Value Engineering Study Report
Project –IM-75-3(189)
Gordon County

Redbud Road, P.I. #610750

RE: Submittal of the final Value Engineering Report
IM-75-3(189) Redbud Road
PI No.: 610750 Gordon County
PBS&J Project Task Order No. 6

IM-75-3(189) – Redbud Road
Gordon County, Georgia

DESCRIPTION: USE GDOT SUPERPARATION OF 100' LIMITED ACCESS

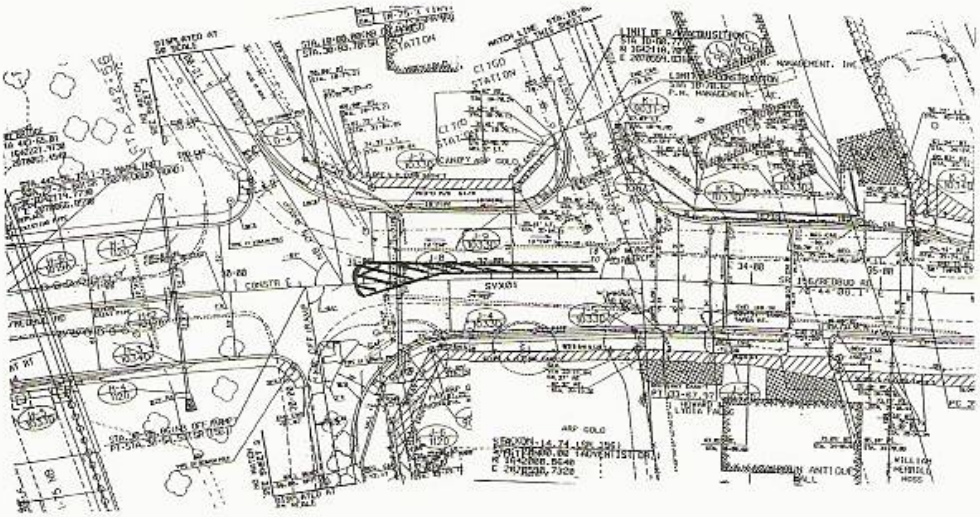
ALTERNATIVE DESIGN - DELETE CONCRETE MEDIAN
100' LIMITED ACCESS

ALTERNATIVE DESIGN - DELETE CONCRETE MEDIAN
THERMOPLASTIC TRAFFIC STRIPING FOR
DEVELOPMENT OF LEFT TURN LANE

DESCRIPTION: MOVE SOUTHBOUND ON/OFF TO THE EAST
MOVE NORTHBOUND ON/OFF TO THE WEST SHEET NO.: 2 of 3

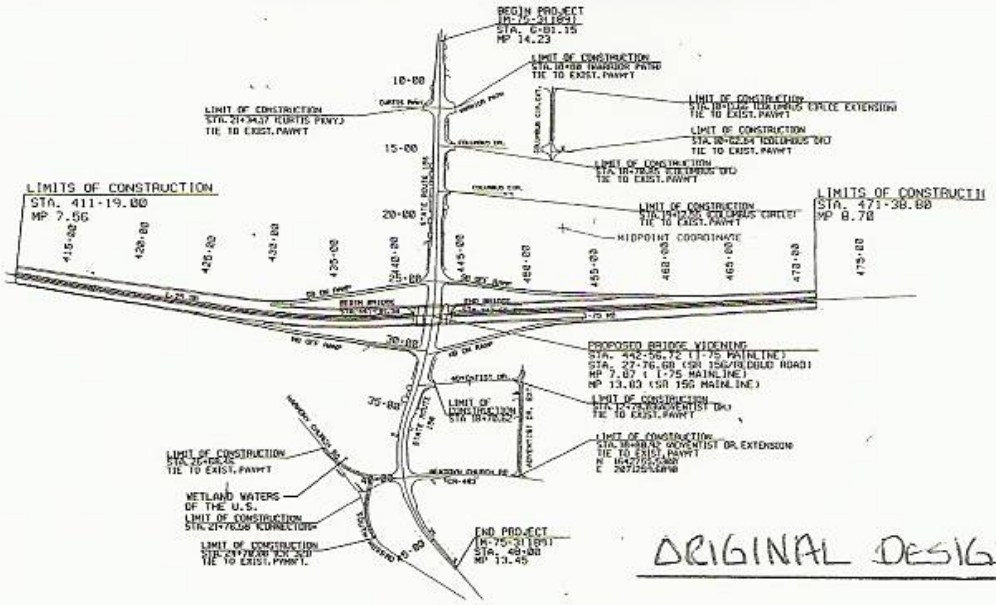
RAMP CONSTRUCTION COSTS WOULD NOT CHANGE AS THE RAMP QUANTITIES WOULD REMAIN THE SAME. COST SAVINGS FOR THE ELIMINATION OR REDUCTION OF RETAINING WALL #1 WOULD BE OFFSET BY THE REQUIRED STAGING OF THE RAMP CONSTRUCTION AS THE NEW RAMP WOULD CROSS THE EXISTING RAMP AND UTILIZING EXISTING PROFILE GRADE INFORMATION WOULD REQUIRE TEMPORARY PAVING OR CLOSING THE RAMP FOR A SHORT DURATION.
